**OICA comments on the
EVE-IWG status report to GRPE-73
(informal GRPE-73-23, GRPE-73 agenda item 10)**

**Electric Vehicles and the Environment
(EVE IWG)**

Figure 21 Cycle life of the LiFePO₄/graphite cells for symmetric cycles at 1, 2 and 4C-rate and the fitted empirical cycle life relation as a function of temperature and current rate (EOL = 20% capacity fade)

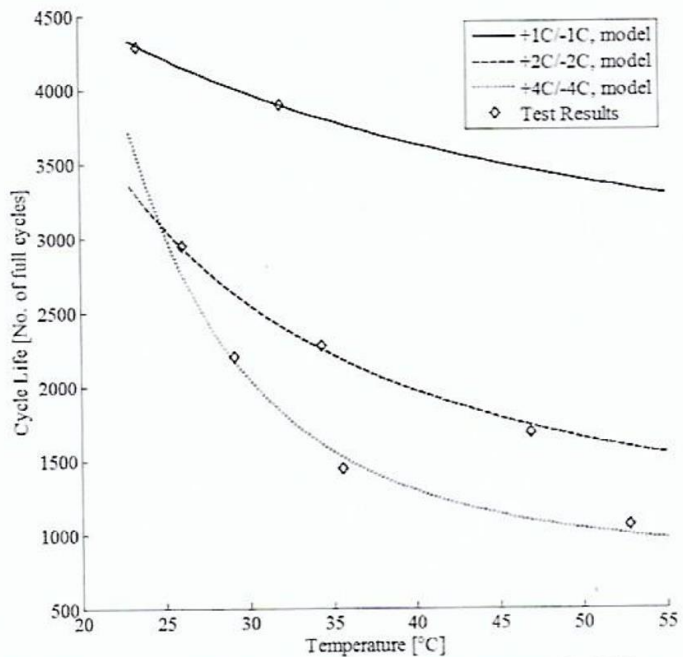
- Aging mechanisms are known to be non-linear and interdependent, hence, accelerated testing of cycle life has proved to be very difficult
- Previous experience of a battery type in a given application is not transferable to another battery in the same application nor for the same battery to a different application
